CLAREMONT BUSINESS PARK 2

“AMENDMENT” OF THE
PRELIMINARY DRAINAGE REPORT
FOR
CLAREMONT COMMERCIAL
SUBDIVISION FILING NO. 2
A RESUBDIVISION OF TRACT C OF
CLAREMONT BUSINESS PARK FILING NO. 2

JULY 2020

Project #44-037
PCD – SP 197

CLAREMONT BUSINESS PARK 2				
PROPOSED DRAINAGE MAP				
PROJECT NO. 44-037A	FILE: \\dwg\Eng Exhibits\44037-PDRM.dwg	DATE: 07-01-2020		
DESIGNED BY: GW	SCALE: HORIZ: 1"=60'	VERT: N/A	SHEET 1 OF 1	PDM01
DRAWN BY: CLP				
CHECKED BY: VAS

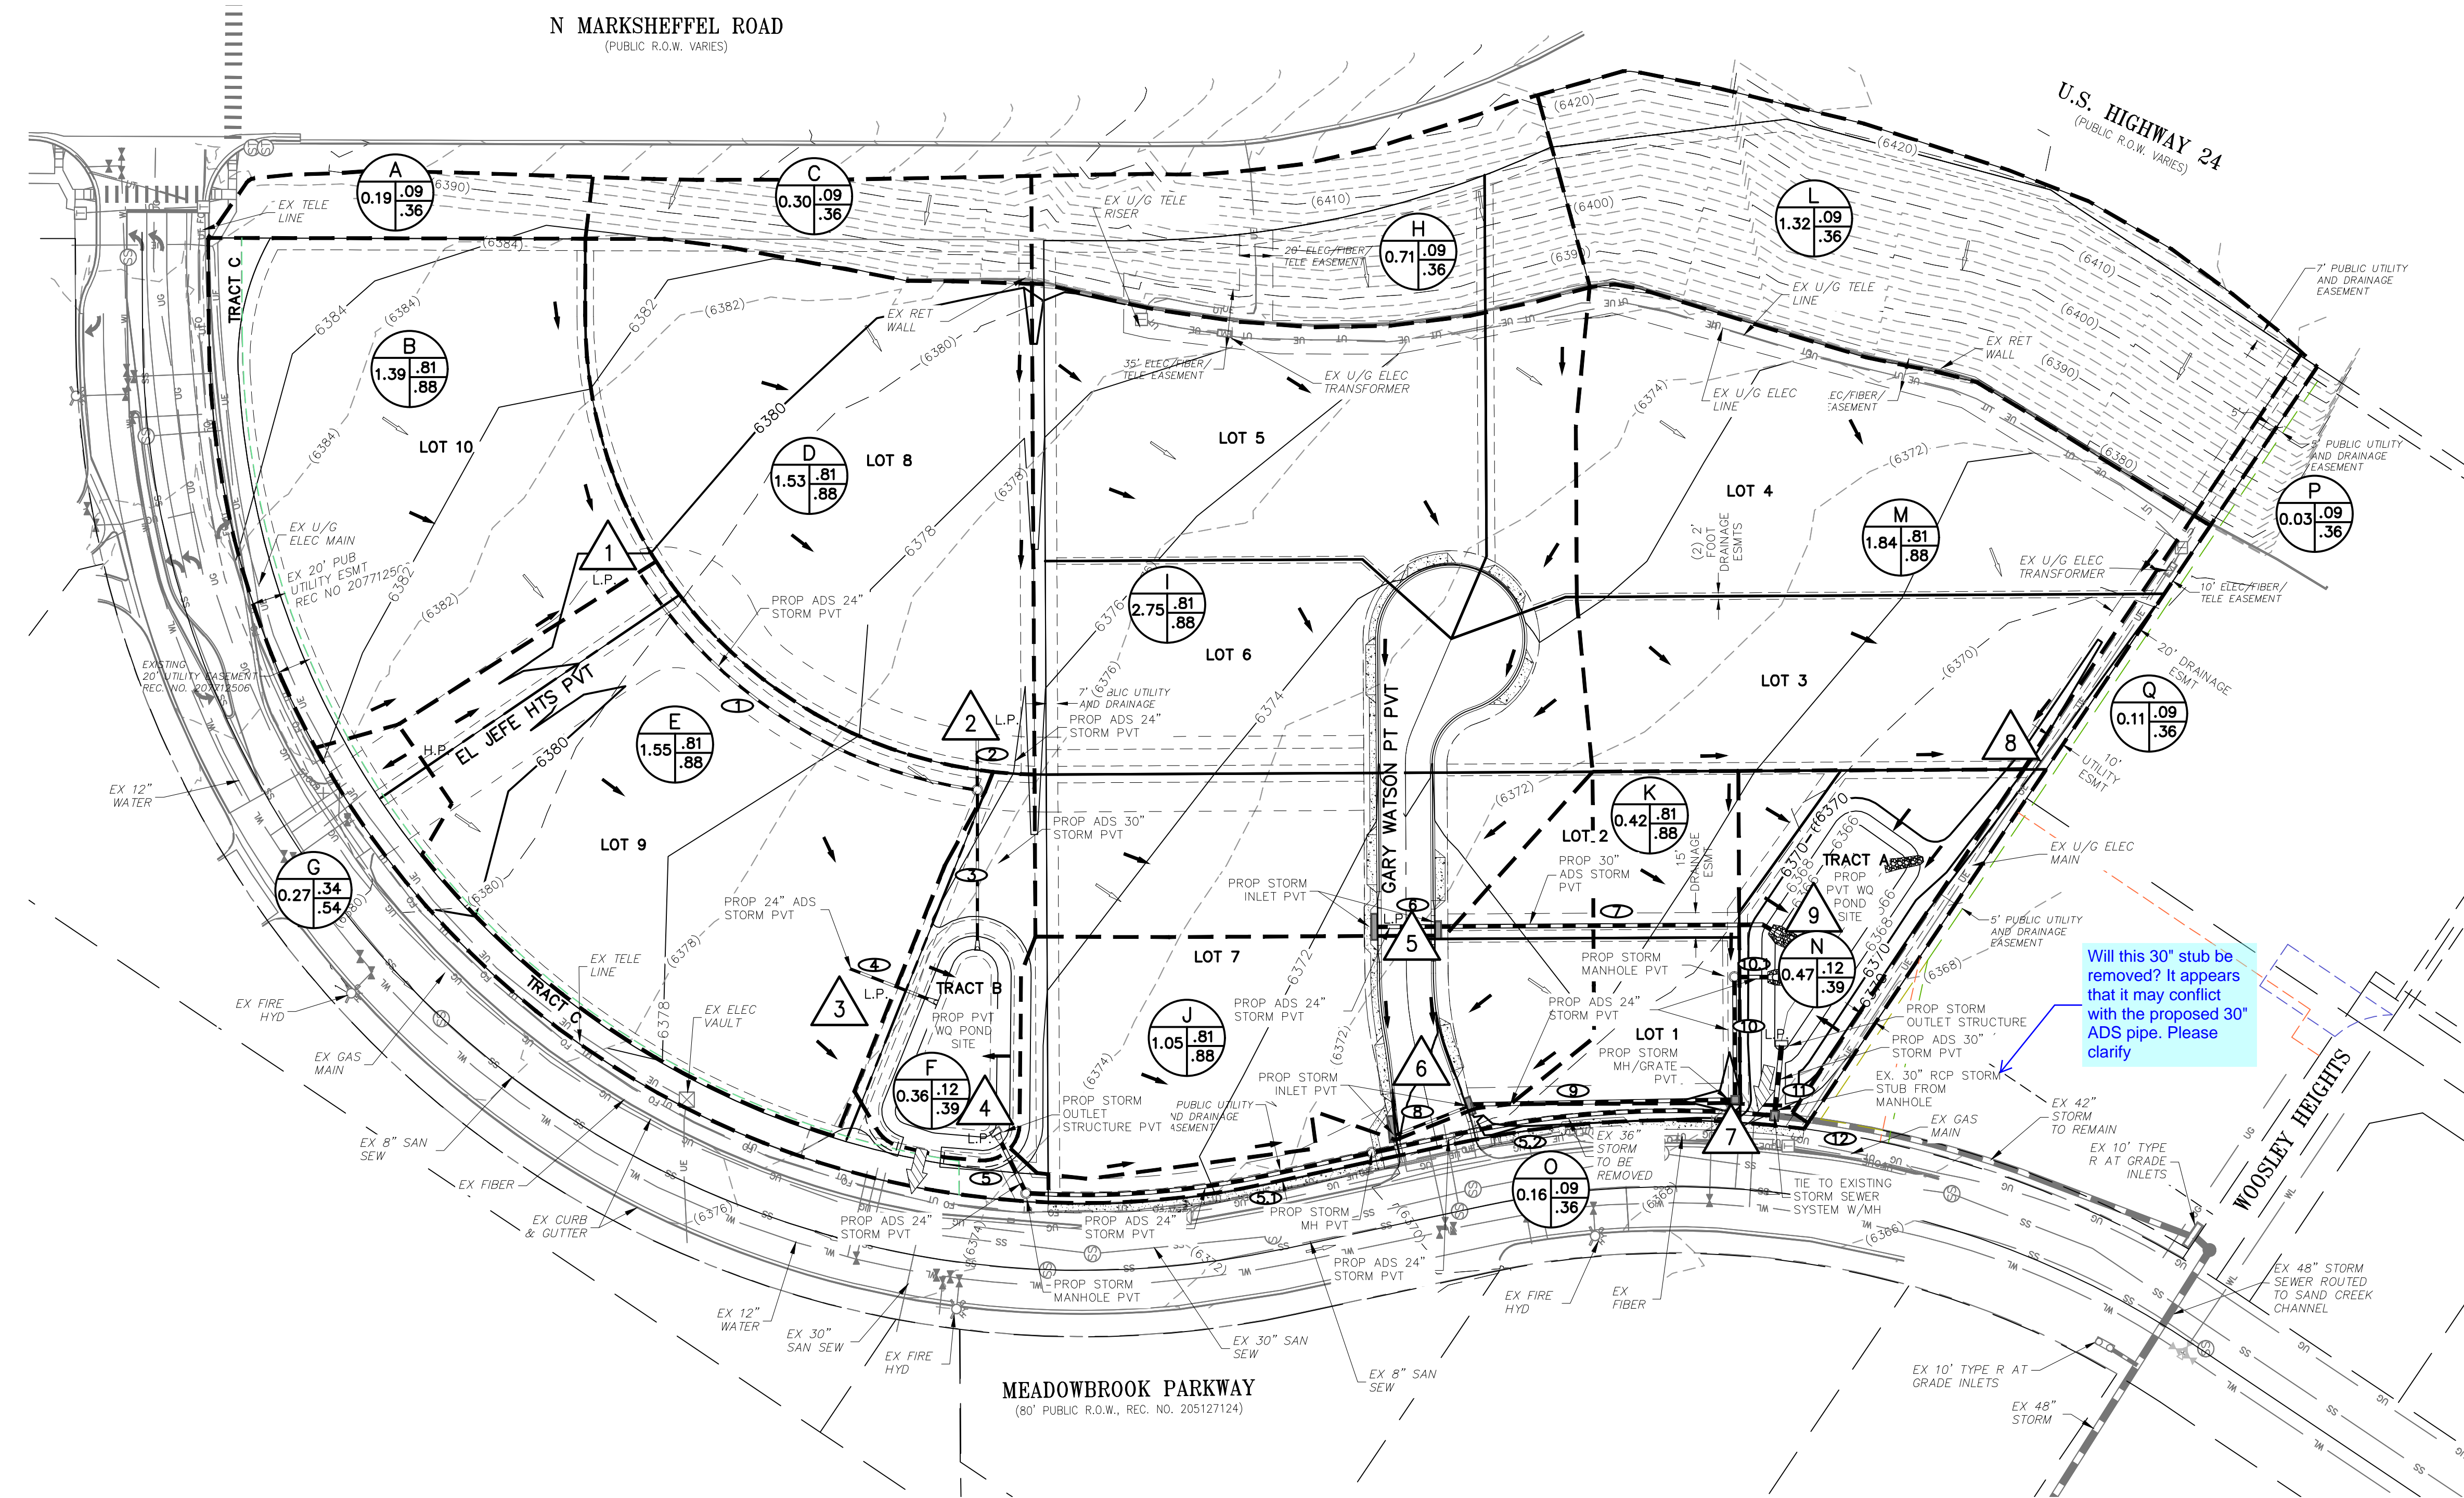
Please provide the drainage map at the end of the report.
